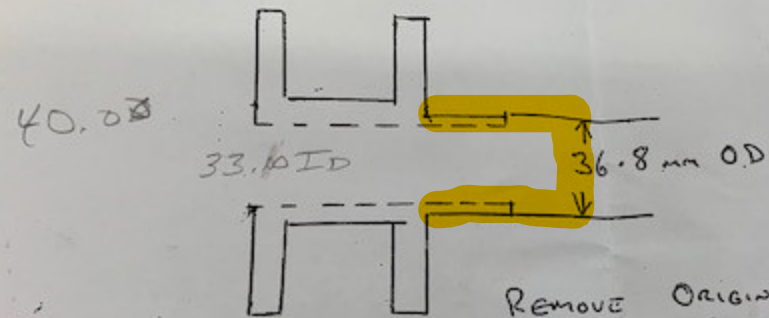
The release bearing needs to get closer to the fingers.
To do that, the length of the bearing mounting
surface needs to be longer.

REMOVE ORIGINAL BEARING
+ REDUCE FITTING ϕ TO 36.8 mm O.D
THIS WILL ALLOW THE REVISED
BEARING TO F.T THE ORIGINAL
CARRIAGE
